Notice of Decision

FILE NOS.: SDP16-00003, PRJ14-00006

PROJECT: **CLARK ELEMENTARY AND GIBSON EK HIGH SCHOOL**

REQUEST: Site Development Permit APPROVAL for a proposed redevelopment of the existing Issaquah Middle School site to accommodate the relocation of Clark Elementary School and a new Gibson Ek High School in the existing buildings, and addition of portables for a new "Academy of Community Transition" program and administration offices.

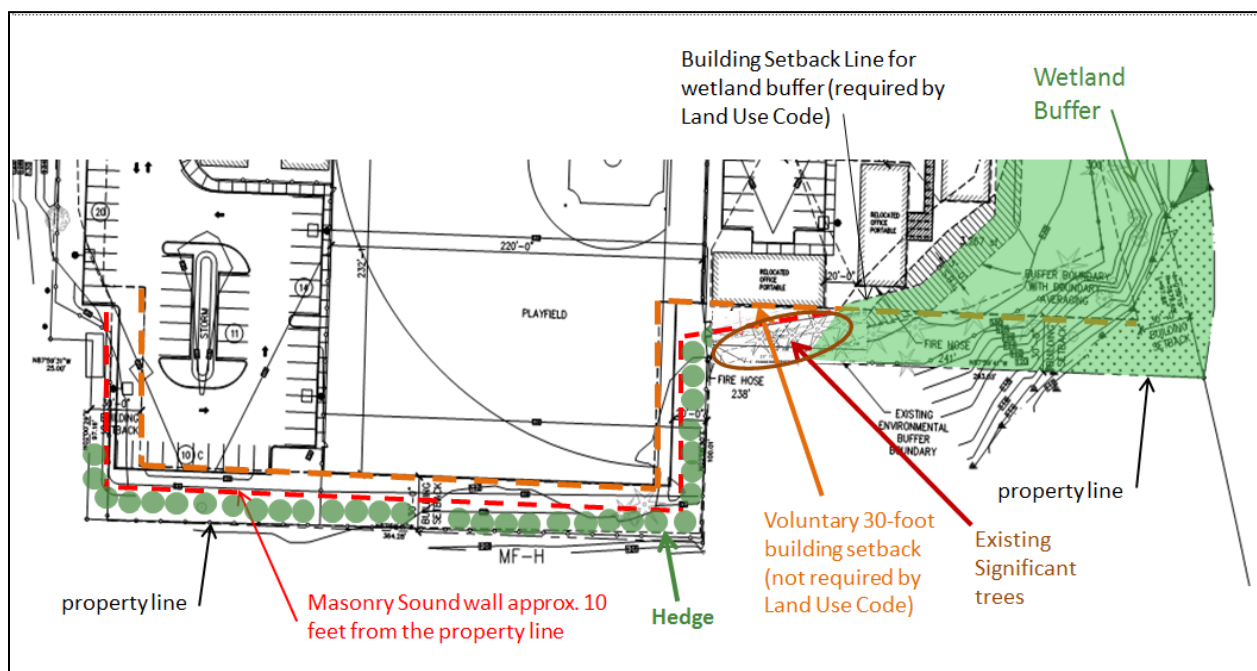
At the Public Hearing, the Commission asked the Applicant to reconsider the amount of parking on-site so as to reduce the impervious area, noting that the Applicant is providing more parking than required by the Land Use Code. The Land Use Code provides for a minimum parking requirement but not a maximum number, so the Applicant complies with the Code despite providing 15 parking space above the requirement. The Applicant will revise the dimensions and location of the parking lots along the eastern property line to reduce the amount of impervious surface and the encroachment into the wetland buffer. The Applicant will also replace the river rock for the portable offices and classrooms with pervious landscaping.

- N. The Applicant provided additional information regarding the screening location and material proposed for the south end of the campus. The Applicant is proposing an 8-foot tall masonry wall starting from the western end of the south property line up to the building setback line for the wetland buffer on the east end of the property. Condition #2 of the staff report was revised to clarify the length of the masonry wall and the type of wall to ensure that it will not only provide visual screening for the residential properties to the south, but also mitigate for sound. The Applicant has agreed to use a masonry wall with sound attenuating properties, which were used in the past at other schools.

During the public hearing, the Development Commission further revised the staff-recommended Condition 2 to clarify the minimum height of the fence. The revised text is shown in italics:

A masonry wall ***with sound-absorbing properties***, no greater than 10 feet tall ***and no less than 8 feet tall***, and set back 10 feet from the property line, shall be provided to mitigate the noise, light and visual impacts of the bus loop and parking lot at the southwest corner of the site. A row of evergreen hedge shall be planted between the wall and the property line to provide a green transition between the residences and the wall. ***The wall shall extend along the south property line up to the building setback line for the wetland buffer.***
